STATE OF NORTH CAROLINA
DEPARTMENT OF TRANSPORTATION

Subject: DCM Consistency for the proposed US 70 Havelock Bypass in Craven County. TIP No. R-1015. WBS 34360.1.2.

The purpose of this letter and information package is to provide information on modifications to our plans for the Havelock Bypass, now under construction. These changes may require a revision to the Division of Coastal Management's CAMA Consistency Determination for the project. This package includes supplemental information in this letter, revised permit drawings and a revised Division of Mitigation Services acceptance letter.

**PERMIT DRAWING
SHEET 17 OF 167**

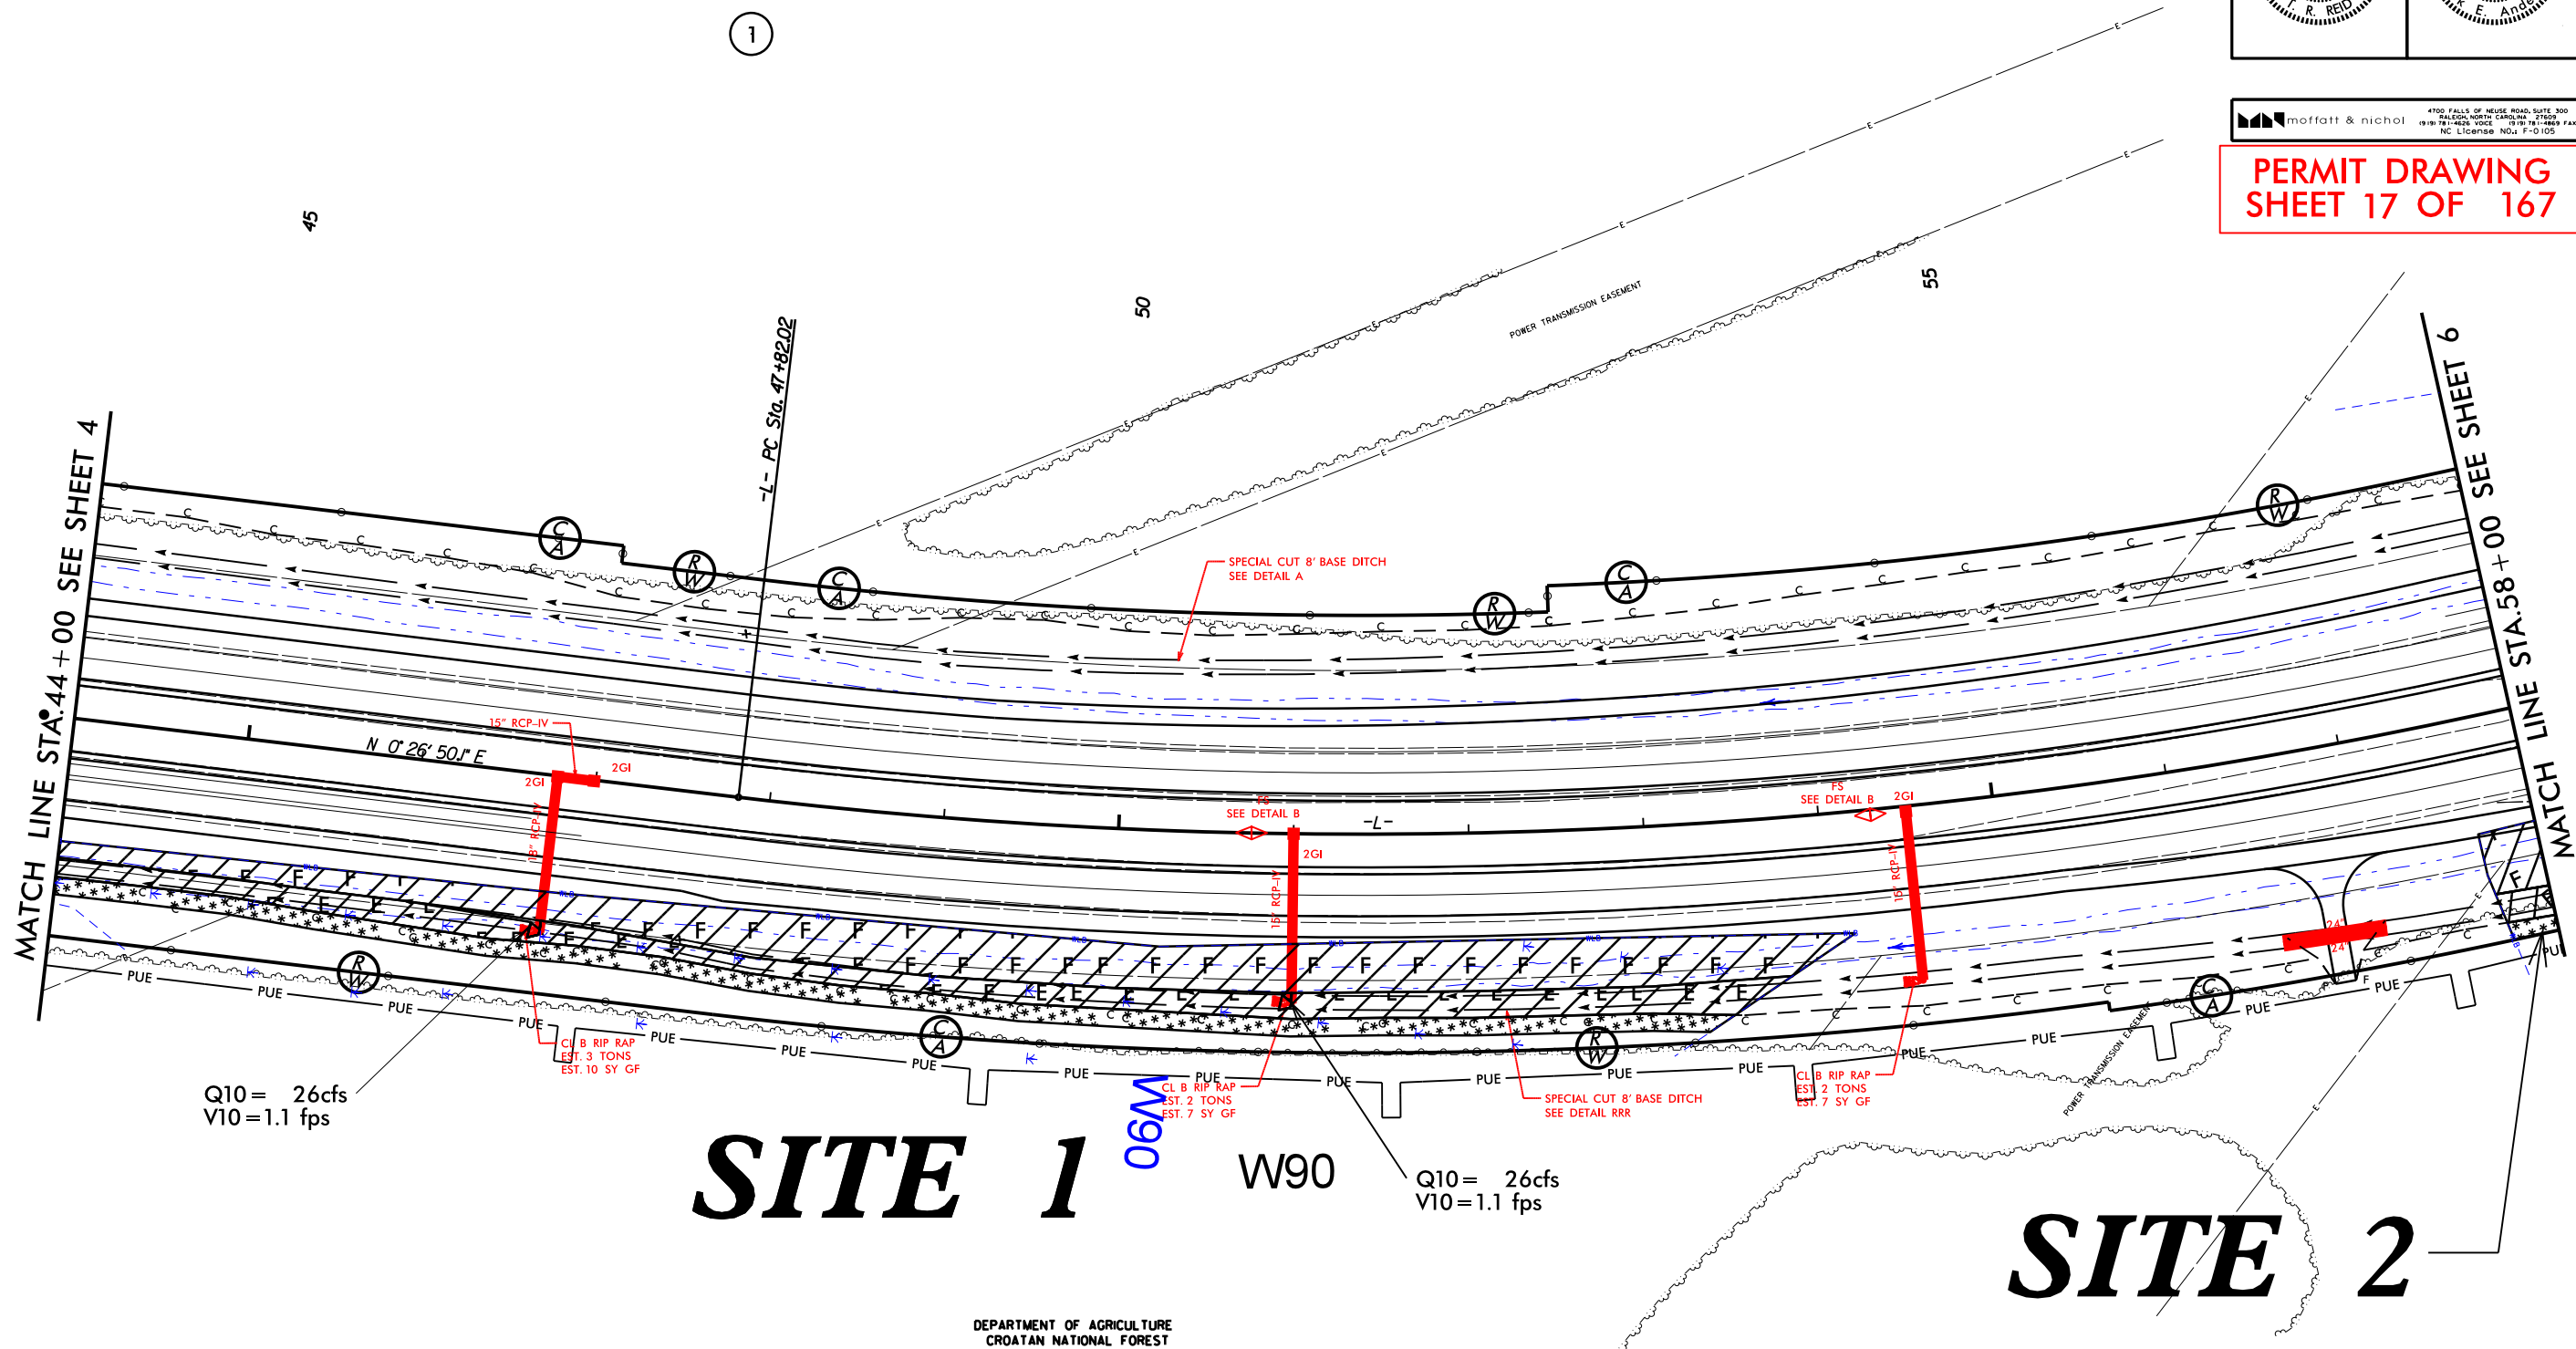
- Detail sheets updated (permit drawings 2 & 3)
- Site 1 (permit sheets 17&18) added riprap in the excavation area due to riprap pads at two pipes. A driveway was added, which did increase the impacts from fill, but decreased the mechanized clearing and excavation. The permitted total (1.16 acre) did not change.

PERMIT DRAWING
SHEET 124 OF 167

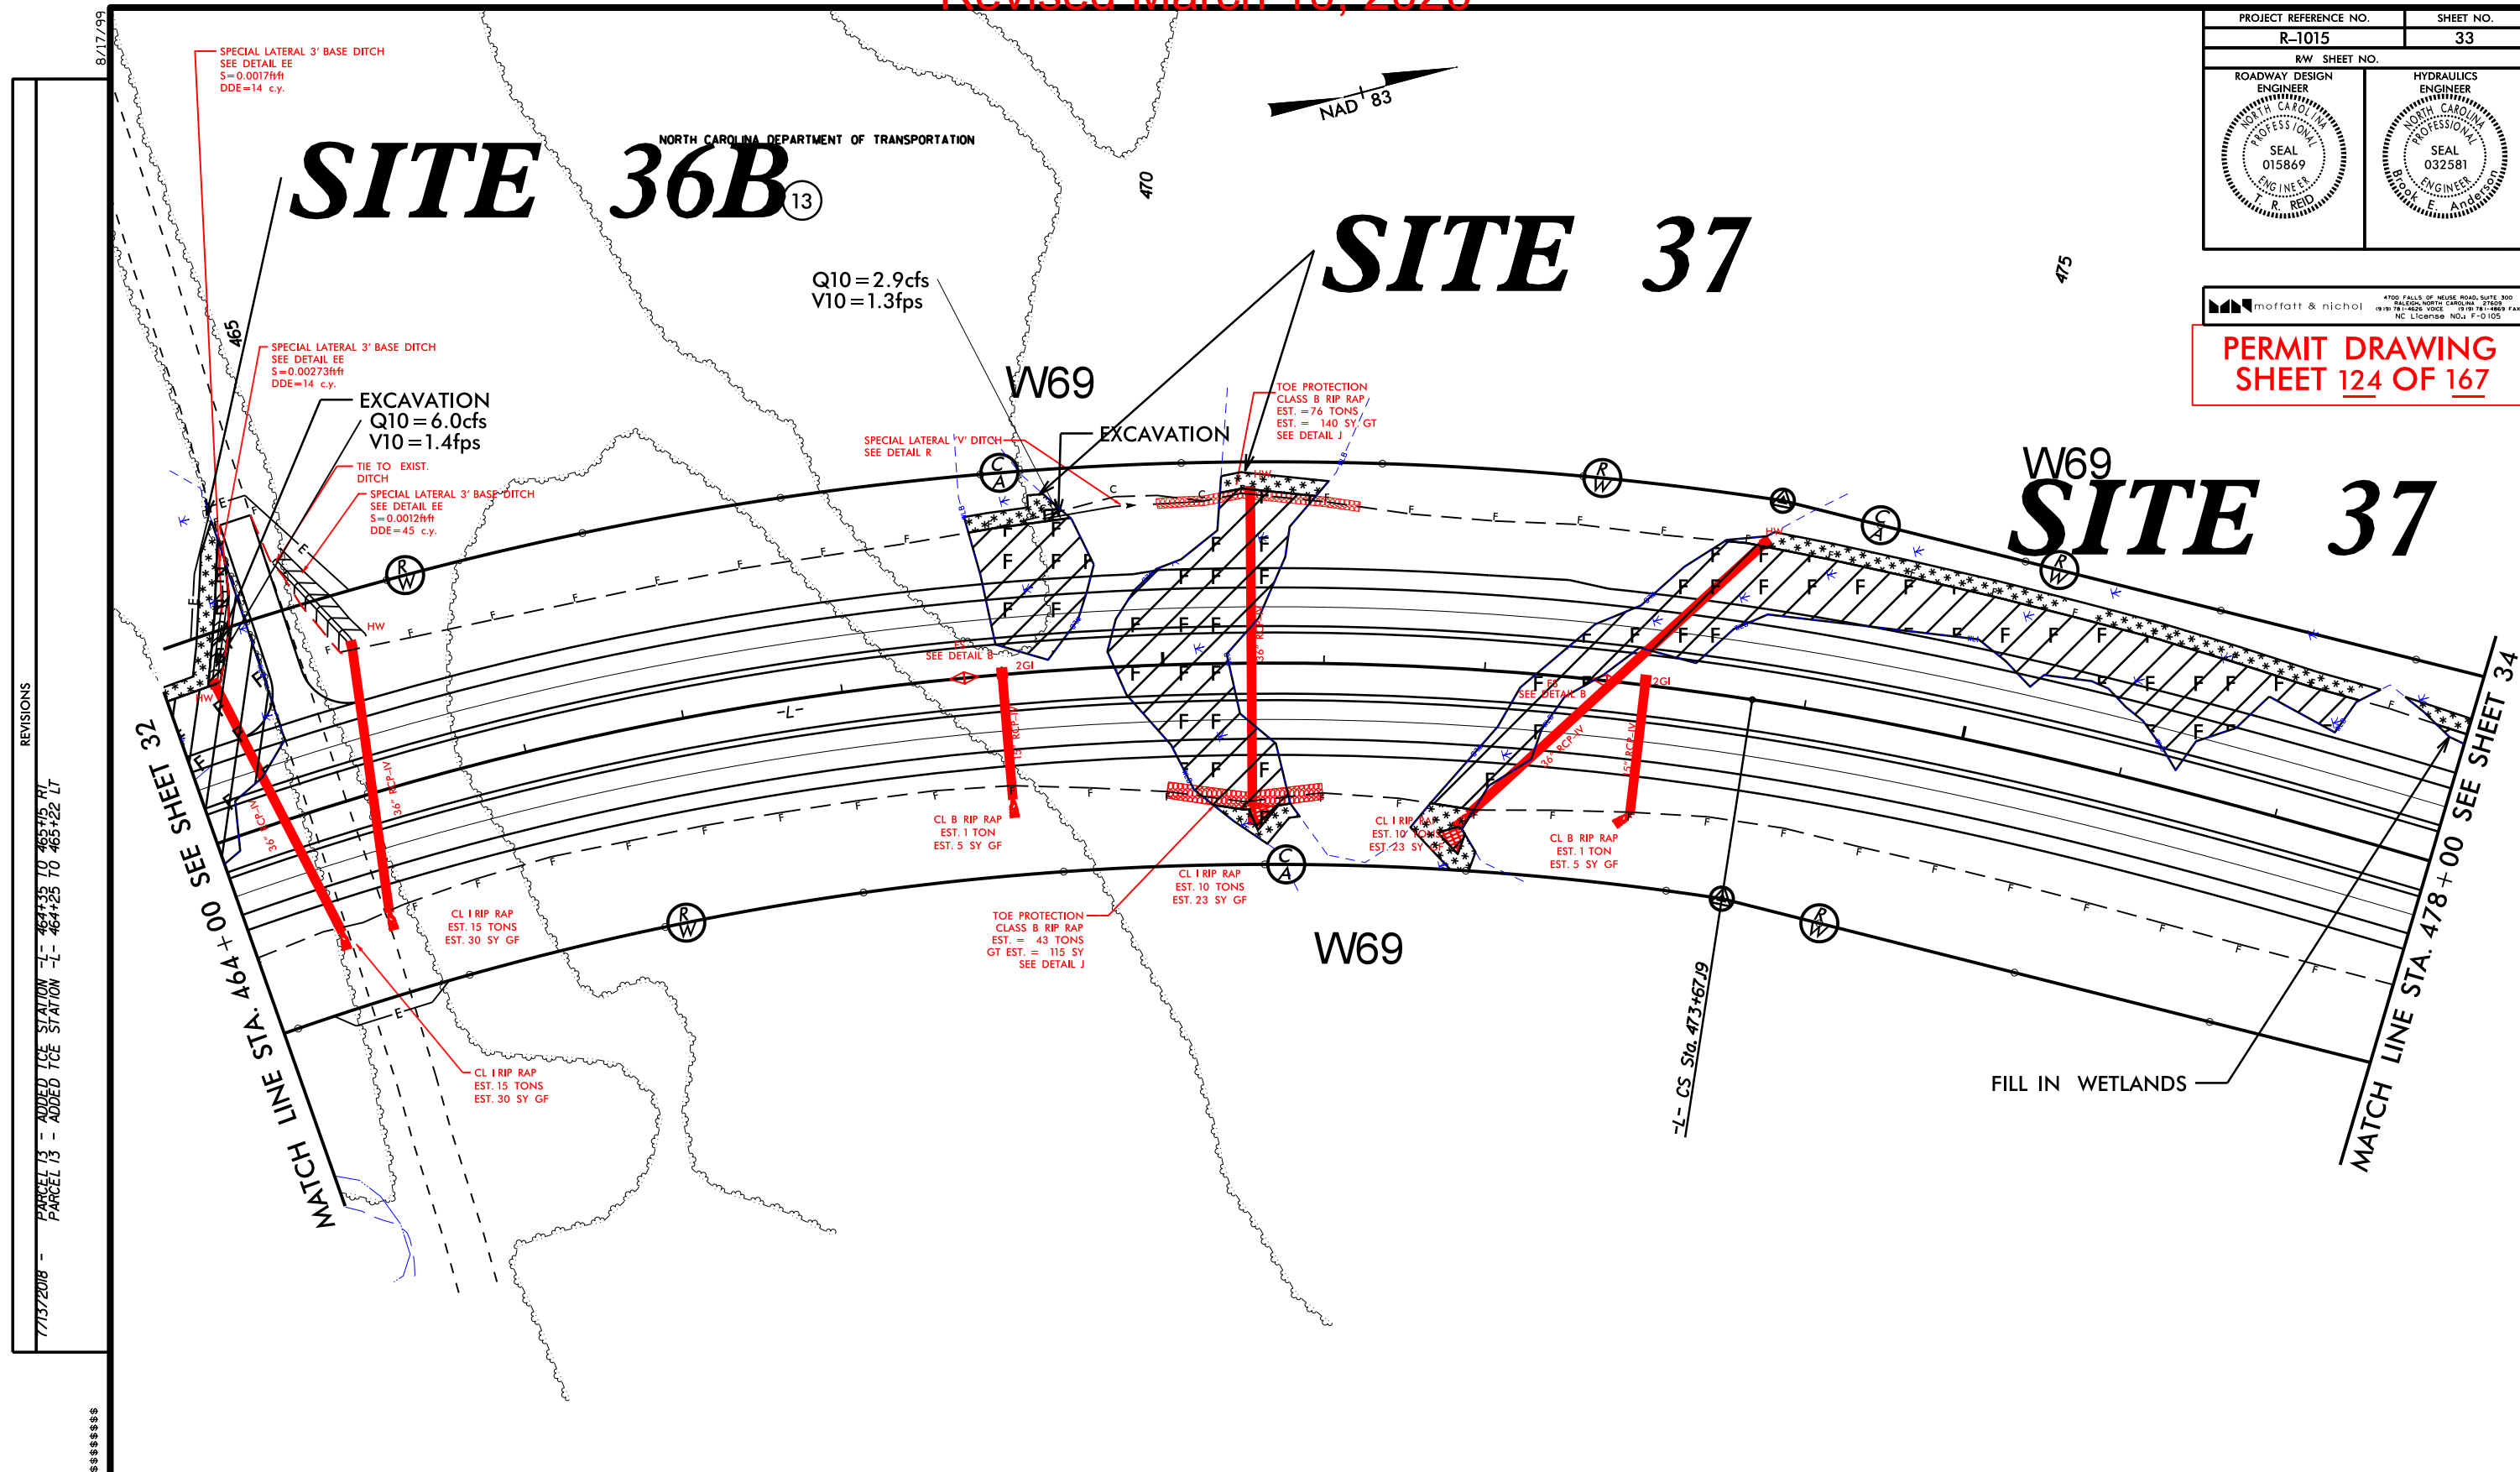
- Update to permit sheets 124 & 125. Changes were outside of impacted areas
- Update to permit sheets 130 & 131. Changes were outside of impacted areas
- Site 47, (permit sheets 142 & 143) pipe shortened to eliminate easement on property, HW added. "Temporary Impacts in Surface Water" reduced by 0.01 ac. "Existing Channel Impacts Temp." reduced by 10'.

PERMIT DRAWING SHEET 148 OF 167

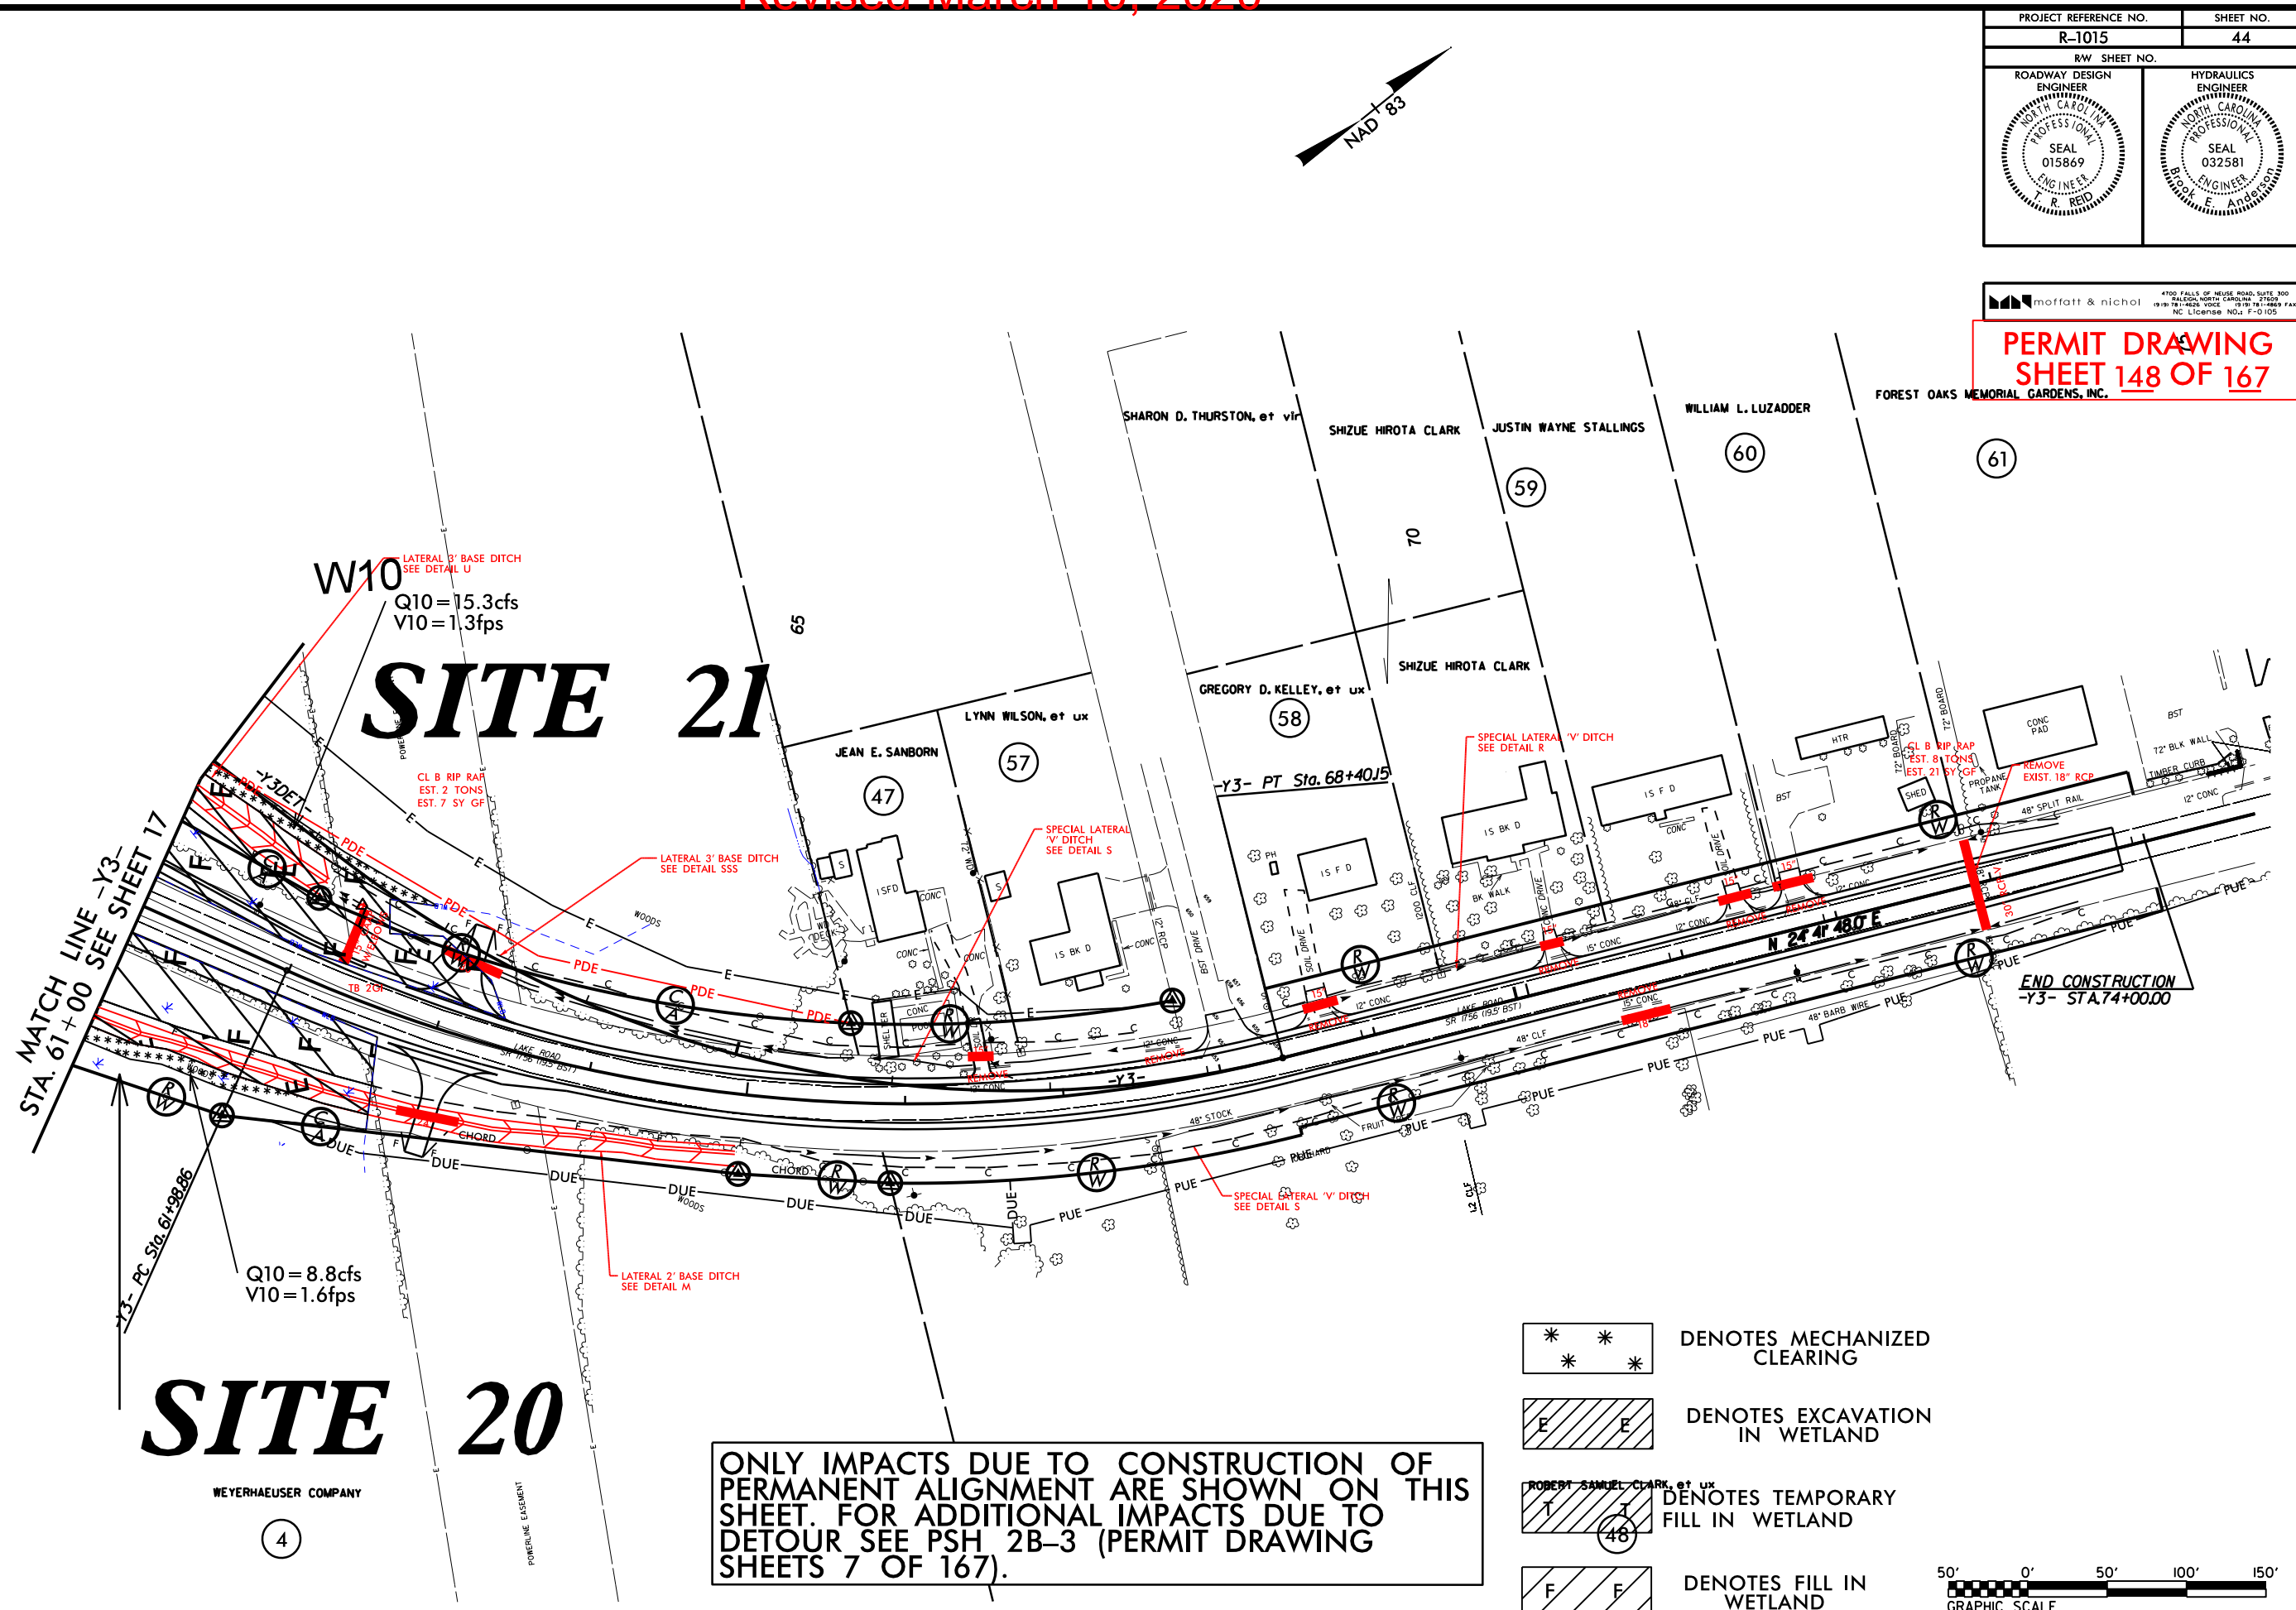
- Site 21 (permit sheets 148 & 149) pipe outlet shifted. Fill increased, excavation decreased, no change to total impacts permitted for site (0.85 acre).
